Service Bulletin

Subject: WIND NOISE FROM REAR DOOR AREA	Bulletin No: 09-007/13
	Last Issued: 03/13/2013

APPLICABLE MODEL(S)/VINS

2013 CX-5 vehicles with VINs lower than JM3KE*****140662 (produced July 30, 2012)

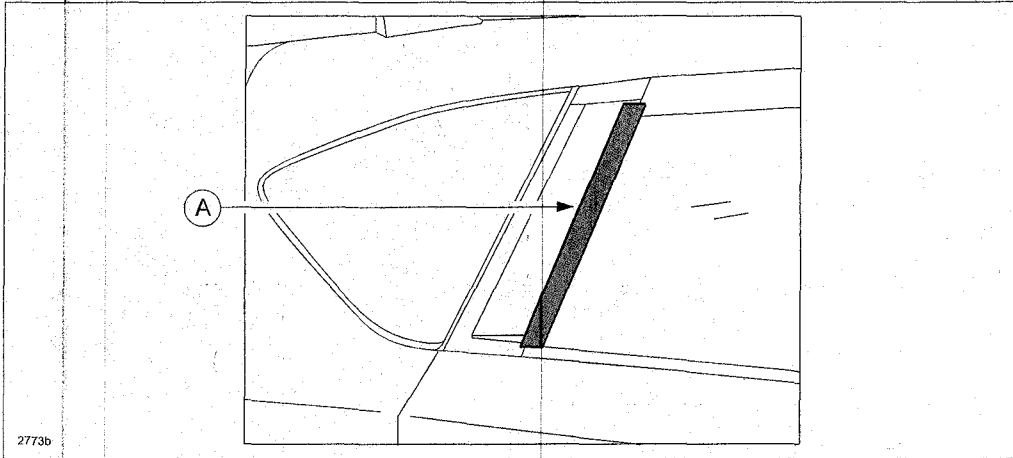
1. Verify the wind noise occurs by putting masking tape (A) to cover the gap between the rear door quarter glass and the rear door garnish. Test drive the vehicle to verify if the wind noise is gone or not.
 - If the wind noise is gone, proceed to next step of the service bulletin repair procedure.
 - If the wind noise is still present, this repair is not applicable. Proceed to section 09 of MS3 online or the Workshop Manual for additional repair procedures.

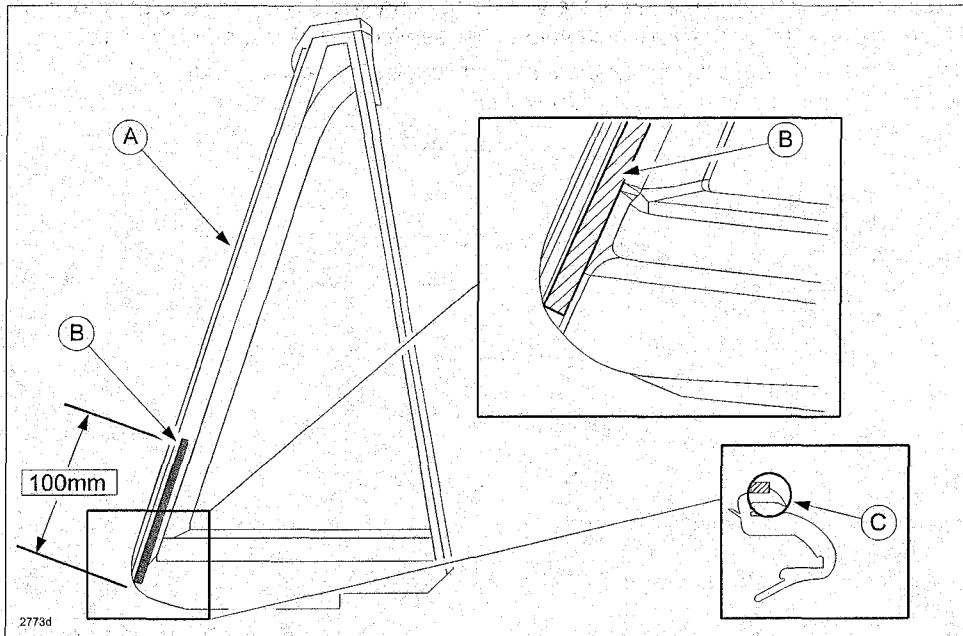
4. Degrease and clean the shaded area of the rear door quarter glass guide (A).
5. Attach the pad (B) in the shaded area.

NOTE: Avoid gap between pad and wedge lip (C).
